## Product Change Notification: CAAN-23LVPD603

CCB 7196.018 Final Notice: Qualification of MTAI as a new final test site for ATF22LV10C-10PU, ATF22LV10CQZ-30PU, ATF22V10C-10PU, ATF22V10C-15PU, ATF22V10C-7PX, ATF22V10CQZ-20PU, ATF750C-10PU, ATF750C-7PX, ATF750CL-15PU and ATF750LVC-15PU catalog part numbers (CPN) available in 24L SPDIP (.300in) package.

**PCN Status:** Final Notification

**PCN Type:** Manufacturing Change

# Pre and Post Change Summary - TUBE

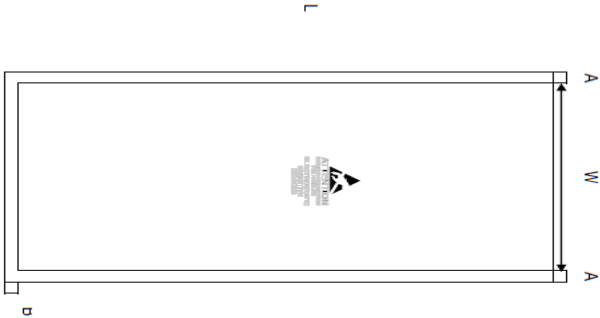
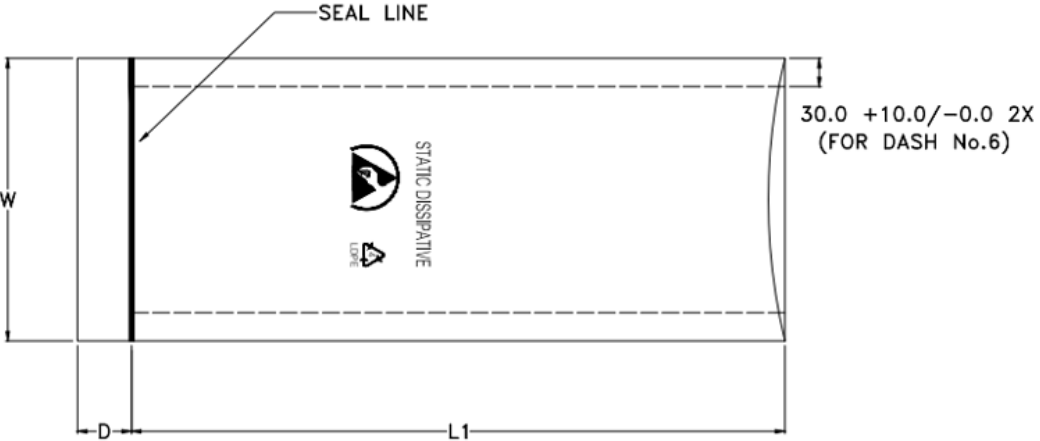
Location	Tube Length (inch)	Hole Usage	Tube Length between Hole Usage	Unit per Tube	Tube per Bag	Tube Color
MPHL	24.00 +/- 0.025	Hole A to Hole B	21.10 +/- 0.05	15	50	Transparent Clear
MTAI	24.00 +/- 0.025	Hole A to Hole B	21.10 +/- 0.05	15	50	Transparent Clear
